APPLICABILITY: 2010-14MY Legacy and Outback Models
SUBJECT: Design Change to Retaining Clip for Front ABS Wheel Speed Sensor

NUMBER: 06-49-15R
DATE: 05/29/15
REVISED: 02/08/16

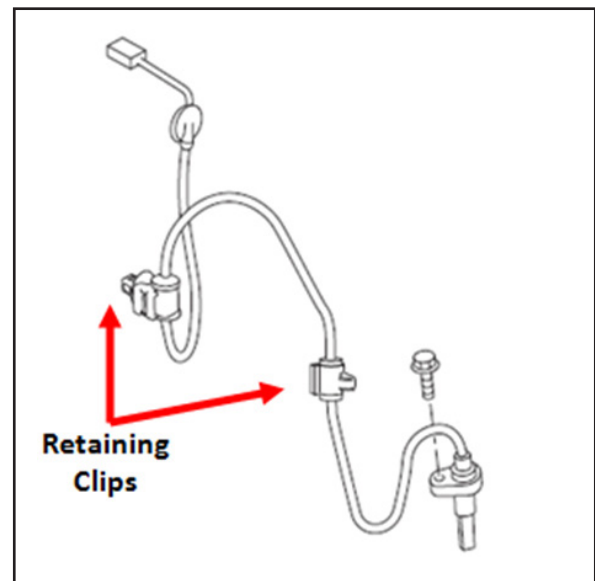
In response to isolated reports of cracked or broken ABS wheel speed sensor harness retaining clips caused by reaction with acids used in some wheel cleaners, the clip material has been changed to polypropylene (PPO).

The new retaining clips can be identified by the molded in >PP< as shown in the photo below. There are 2 clips on each sensor harness.
